RIDGECREST SOLAR POWER PROJECT (09-AFC-9)
DATA ADEQUACY SUPPLEMENT

Technical Area: Water Resources **Response Date: October 26, 2009**

100-Year Flood Plan
Pre- and Post-Project Development

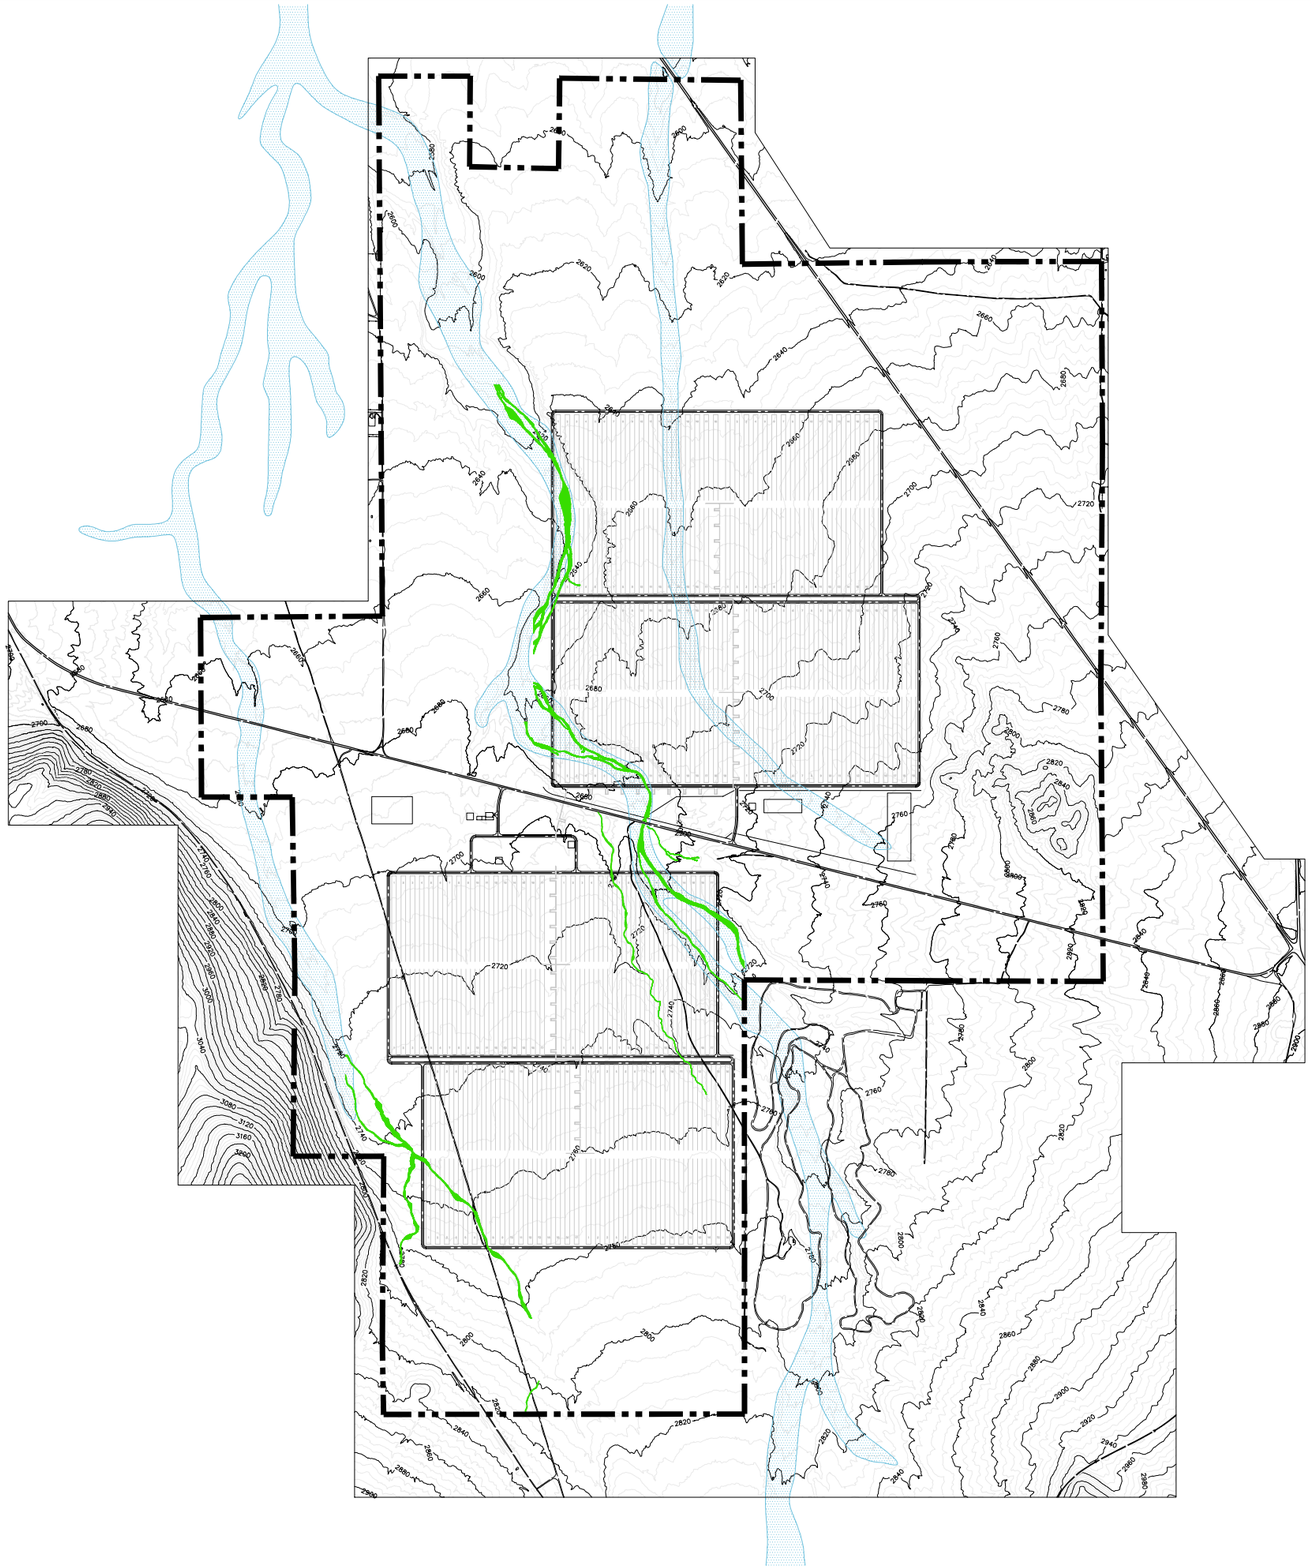
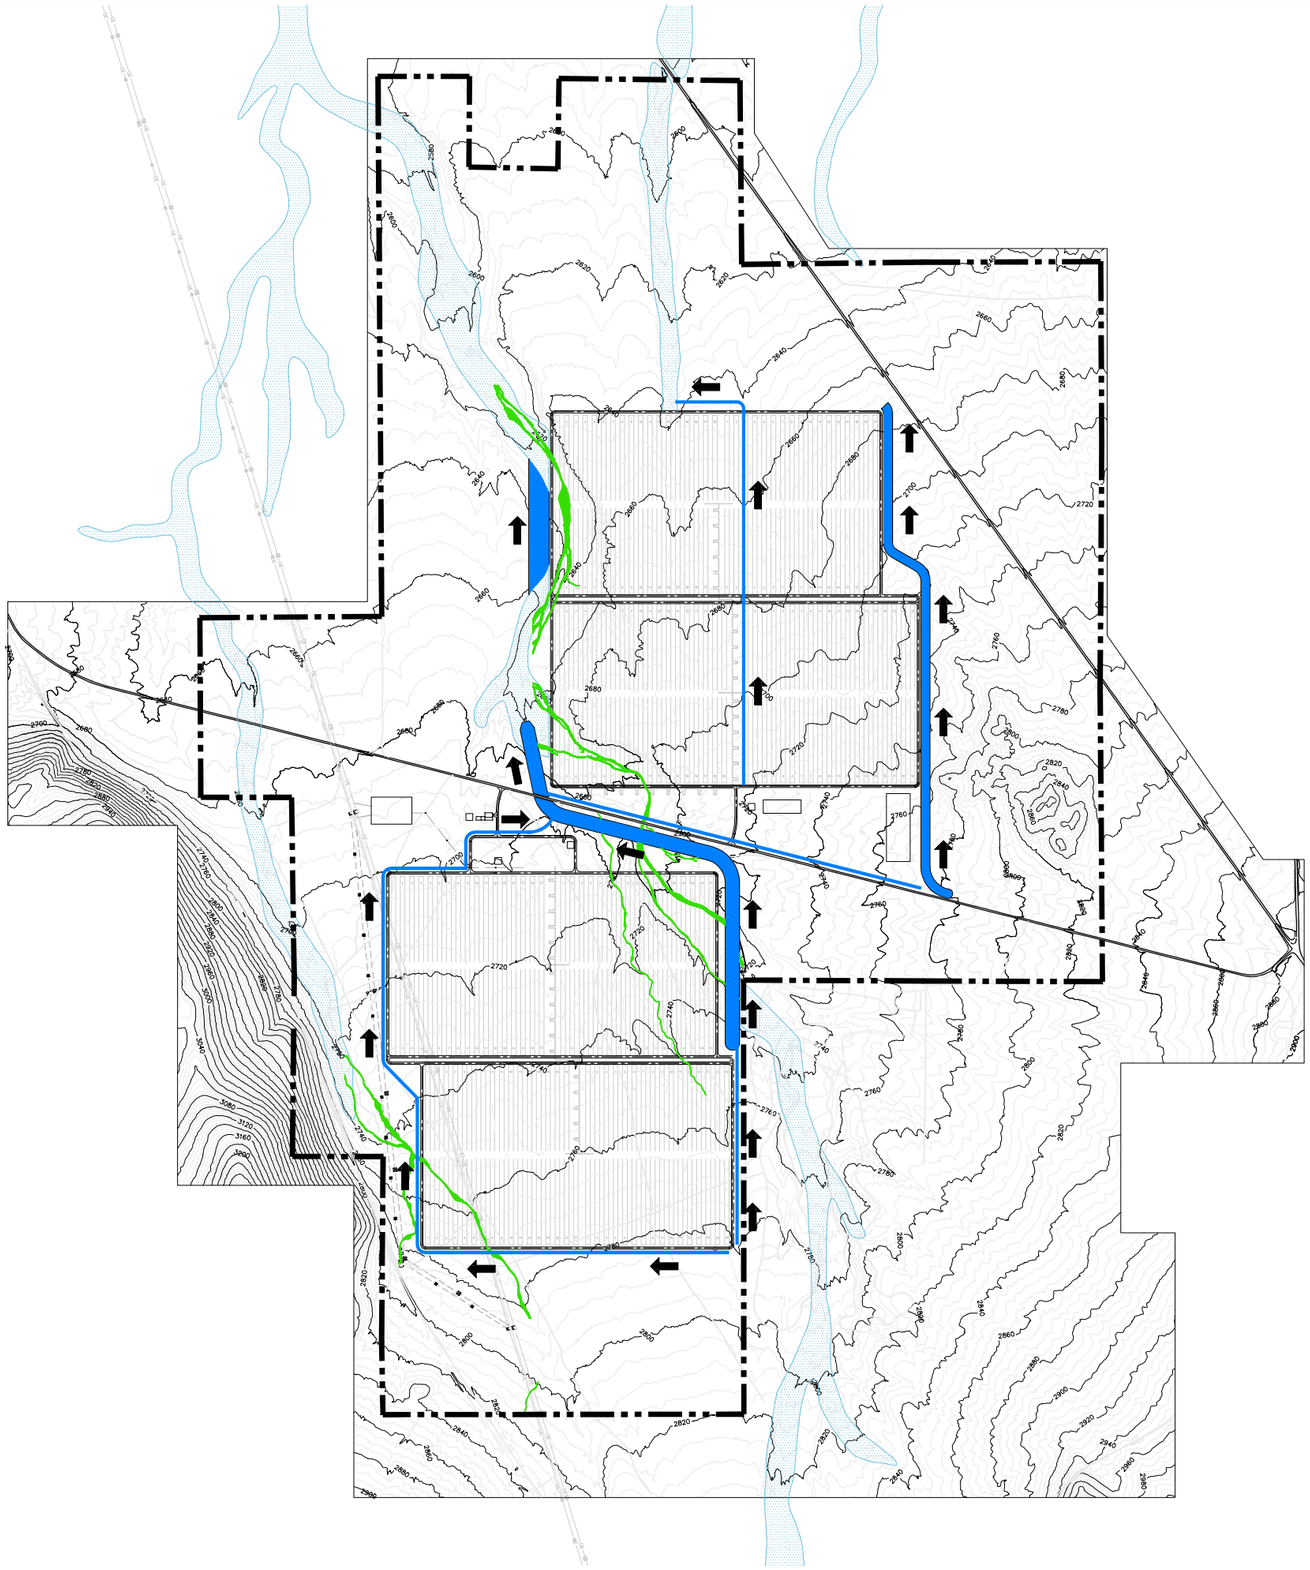
Please provide mapping showing the pre- and post-development 100-year floodplains. Please provide the HEC-RAS input files along with a copy of the drainage report.

The pre-development and post-development mapping showing the 100-year flood plains are attached to this narrative information per coordination and agreement with CEC staff (Attachment WATER-C). A narrative summary of the pre-development and post-development drainage flows onsite has also been provided as part of DA-WATER-4 above. The HEC RAS files for the channels will be provided as supplemental materials on November 25, 2009 per coordination and agreement with CEC staff. The drainage reports have been provided in Appendix L of the AFC.
